The Commission has issued the enclosed Amendment No. 30 to Facility Operating License No. DPR-28 for the Vermont Yankee Nuclear Power Station. The amendment consists of changes to the Technical Specifications in response to your application dated August 26, 1976.

This amendment revises the Maximum Average Planar Linear Heat Generation Rate curves to be consistent with the current design limit linear heat operation rate of 13.4 kw/ft.

Amendment No. 30
License No. DPR-28

SAFETY EVALUATION BY THE OFFICE OF NUCLEAR REACTOR REGULATION
SUPPORTING AMENDMENT NO. 30 TO FACILITY OPERATING LICENSE DPR-28
VERMONT YANKEE NUCLEAR POWER CORPORATION
VERMONT YANKEE NUCLEAR POWER STATION
DOCKET NO. 50-271

180-n (Figure 3.11-1B)

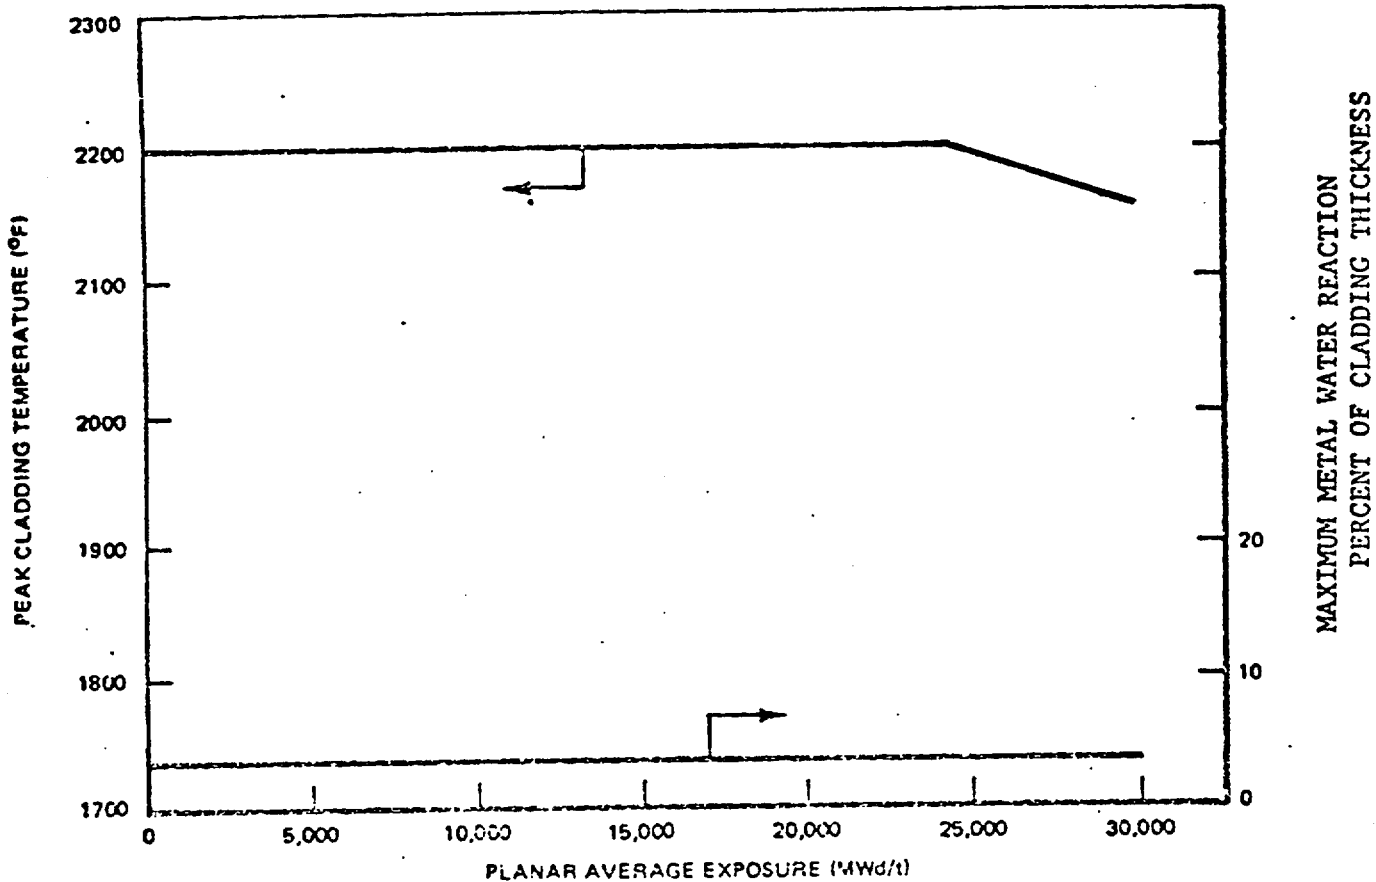
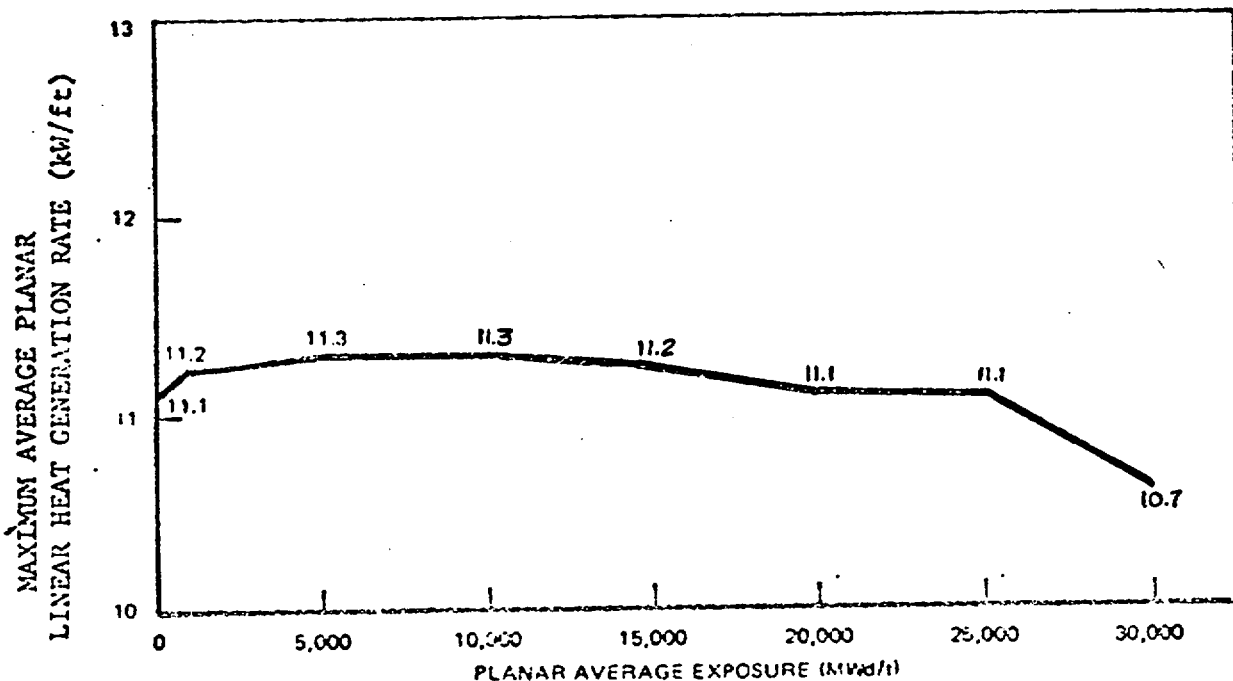
The proposed MAPLHGR limits, based on a peak rod at 13.4 kw/ft, are 0.1 kw/ft lower at certain exposures than the old MAPLHGR limits that were based on a peak rod at 14.4 kw/ft.

Present Technical Specification limits related to MAPLHGR are based on a Design Basis Loss-of-Coolant Accident (DB-LOCA) analysis which assumed a peak Linear Heat Generation Rate (LHGR) for a single rod of 14.4 kw/ft¹, which is different from the current limit. The newly proposed MAPLHGR Technical Specification limits are based on DB-LOCA calculations which assumed the current LHGR limit of 13.4 kw/ft.
